LINOTYPE IMPROVEMENT SHEET

No. 303

FIRST ELEVATOR LEVER LINK SPRING

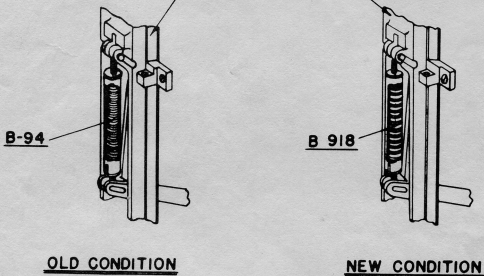
A new First Elevator Lever Link Spring (B-918) has been adopted to replace the present Spring (B-94). This results in a more uniform pressure on the lugs of matrices whether in the highest or lowest alignment position.

Can be applied to all outstanding Models by substituting B-918 for B-94.
